Base Load Power Hub (BLPH)

HAZID Close Out Report

Document Number: 123A90-DDL-SAF-RE-30010

The objective of the present document is to provide a formal close out record for all actions that have been responded to and signed-off. This includes both FEED and EPC Actions coming from HAZID workshops.

PUMP DATA SHEETS INCLUDING WEIGHT DATA SHEET
For Sea Water Lift Progressive Cavity Pumps (P-50001 A/B)

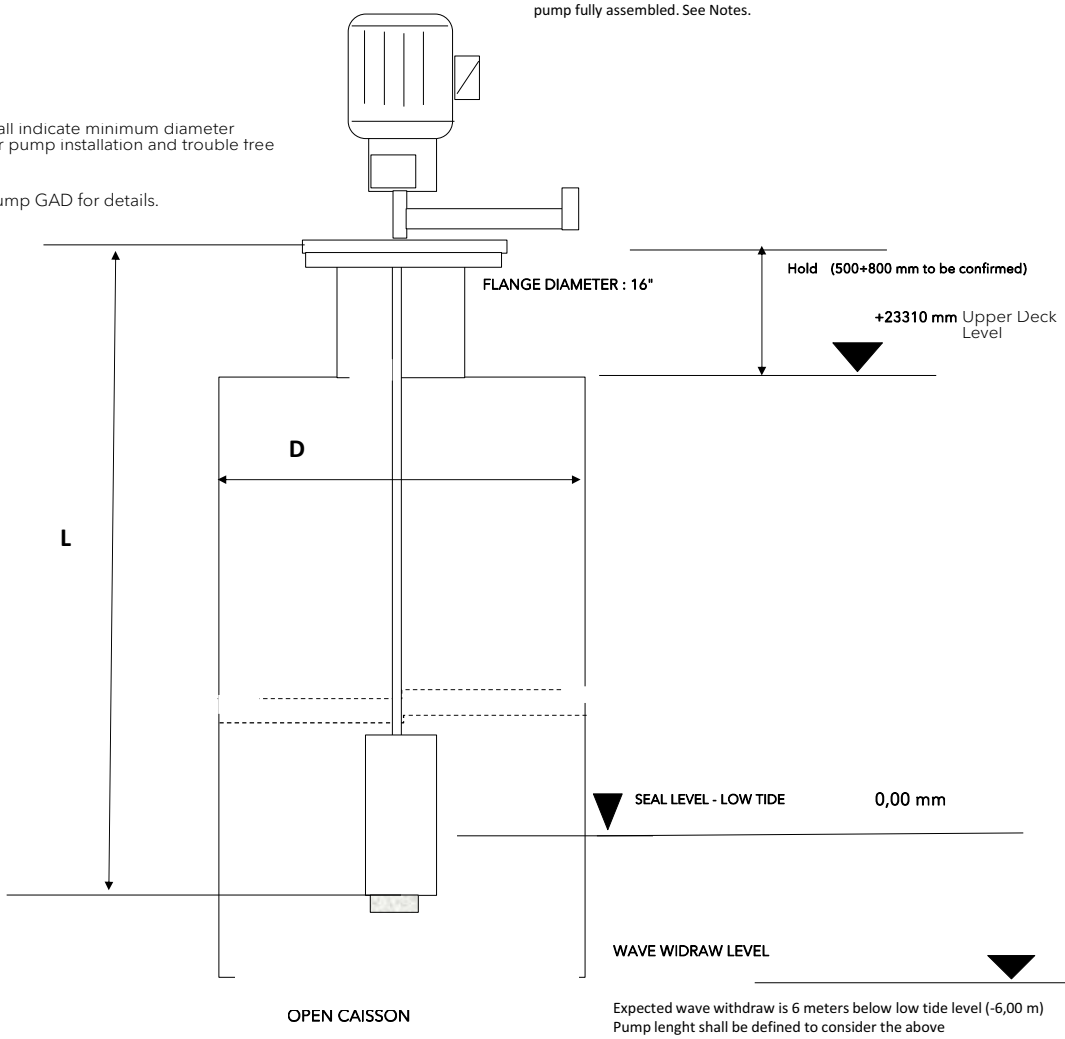
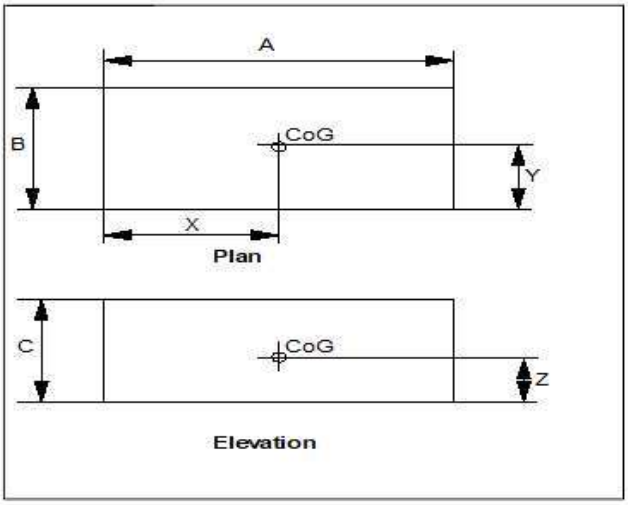
Action N : 13	**Rev.:** 001
Action Title: HAZID Study	**Date:** 05/10/2023
Reference Document n:	
Node:3- Water&Utilities	
Hazard/Parameter: Small animals	**Deviation**
Cause: Marine growth or small marine faune	
Consequence: Blockage of sea water intake systems. Impact to process. Potential for fish decomposing and health effect to personnel (scenario not ranked as not sufficient information are available)	
Safeguards: Sea water filtration & chemical dosing systems. Screen on the suction side of pumps. Backwash filter cleaning.	
Recommendation: Verify with Sea Water Treatment System Vendor if it is possible to have fish trapped and decomposing in the package	
Responsible Part: ROSETTI Mechanical

Response: The feed water is delivered by P-50001 A/B out of WTP vendor scope. The pump has been purchased by RM. Pump feature a suction screen 7 mm mesh size, to avoid entry of foreign objects that could clog the pump. Pump internals, and caisson are injected with biocide to avoid presence of microorganisms, muscles spores, algae's, and very small fishes. According with Vendor, tighter mesh is not possible, because affect suction of the pump.	
Ref. Docs / Dwgs.: 123A90-DDL-EL-DG-20015; 123A90-DDL-PP-DS-70070;123A90-DDL-PR-DG-80003; 123A90-DDL-PR-DG-80004;123A90-DDL-PR-DG-80005;123A90-DDL-PR-DG-80006; 123A90-DDL-PR-DG-80007; 123A90-DDLPR-

TITLE :
BASE LOAD POWER HUB (BLPH)
PLOT PLAN
BELOW LOWER DECK

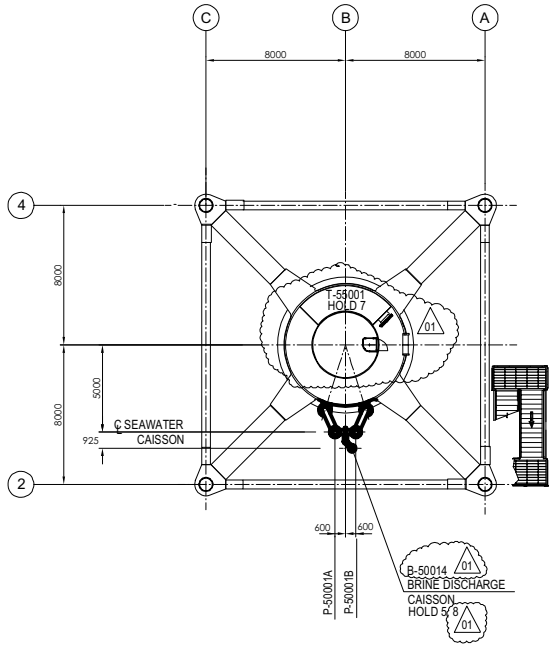
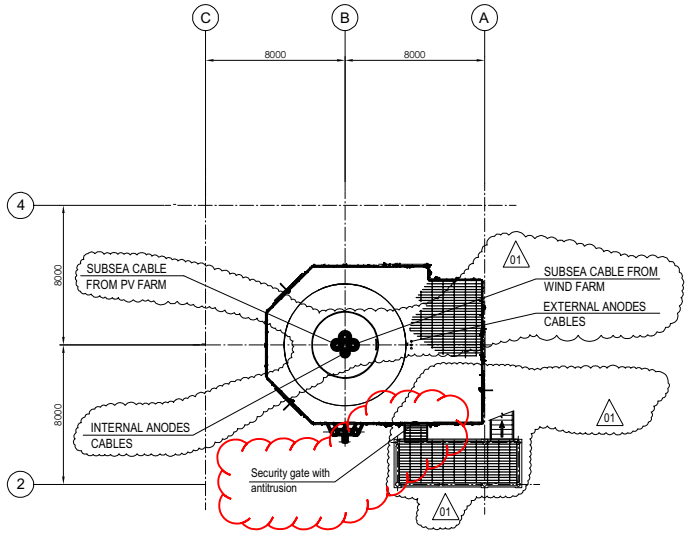
Action N : 14	**Rev.:** 001
Action Title: HAZID Study	**Date:** 05/10/2023
Reference Document n:	
Node: General Node	
Hazard/Parameter: Piracy, hijack, kidnap, terrorism	**Deviation**
Cause: Unauthorised access	
Consequence: Damage to facility	
Safeguards: Surveilance by marine operation HVAC room and electrical room are locked	
Recommendation: Consider to provide physical barrier on the stair	
Responsible Part: ROSETTI Architectural	
Response: An anti-intrusion security gate will be provided at the beginning of the platform access staircase. It will be represented in a Plot Plan Below Lower Deck drawing doc. N. 123A90-DDL-PP-DL-70071.	
Ref. Docs / Dwgs.:
